IMPORTANT SAFETY RECALL NOTICE

Subject: Safety Recall 19E-042 – Prolo Hatches

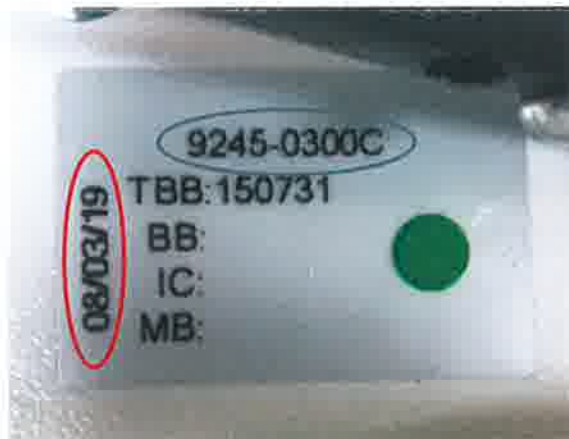
1. Check the label on the bottom of the Prolo Hatch p/n 92XX-XXXXX (circled below in blue) for dates between August 1, 2018 and May 20, 2019 (circled below in red). Units built within this date range are subject to the replacement campaign.

Replacing the outside release handle will resolve the defect. The replacement kit will include (1) replacement handle, associated hardware, and replacement instruction information.
